Access Compliance Report

Public Rights-of-Way

(Curb Ramps)

Intersection ID: 27941	Main Street: JOHN_K_HALL_WY	Cross Street: LANCASTER_HY	Location: NE
ADA ID: 81FF00CC98F5	Ramp Type: Perp	Initial Pass/Fail: Fail	Overall Compliance: No
Severity Score: 21.25			
Codes/Mitigation Info/Possible Solution		Field Measurements/Component Compliance

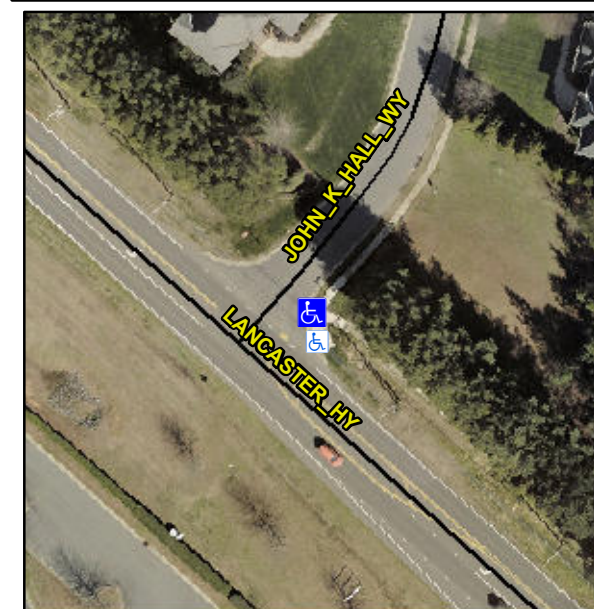
Not Found, R304.5.1, R304.5.3

Compliance	Description	Data	Compliance	Description	Data
N/A	Ramp Length (in)	46.5	Yes	Ramp Slope (%)	5.5
No	Ramp Width (in)	36.0	No	Ramp XSlope (%)	6.1
N/A	Flare Type LT	N/A	N/A	Flare Type RT	N/A
N/A	Flare Slope LT (%)	N/A	N/A	Flare Slope RT (%)	N/A
N/A	Flare Traversable LT?	N/A	N/A	Flare Traversable RT?	N/A
N/A	Landing Length (in)	N/A	N/A	DWS Provided?	N/A
N/A	Landing Width (in)	N/A	N/A	DWS Contrast?	N/A
N/A	Landing Slope (%)	N/A	N/A	DWS Length (in)	N/A
N/A	Landing X Slope (%)	N/A	N/A	DWS Full Width?	N/A
N/A	Landing Curb? (Y/N)	N/A	N/A	DWS Offset (in)	N/A
N/A	Shared Landing?	N/A			
N/A	Gutter Ponding?	N/A	N/A	Gutter Slope (%)	N/A
N/A	Gutter Lip Ht (in)	N/A	N/A	Gutter X Slope (%)	N/A
N/A	Painted X Walk1?	No	N/A	Painted X Walk2?	N/A
	X Walk 1 Direction	To NW		X Walk 2 Direction	N/A
N/A	X Walk 1 Width (in)	N/A	N/A	X Walk 2 Width (in)	N/A
	X Walk 1 Slope (%)	2.1		X Walk 2 Slope (%)	N/A
	X Walk 1 X Slope (%)	5.6		X Walk 2 X Slope (%)	N/A

Remove & Replace Entire Ramp.
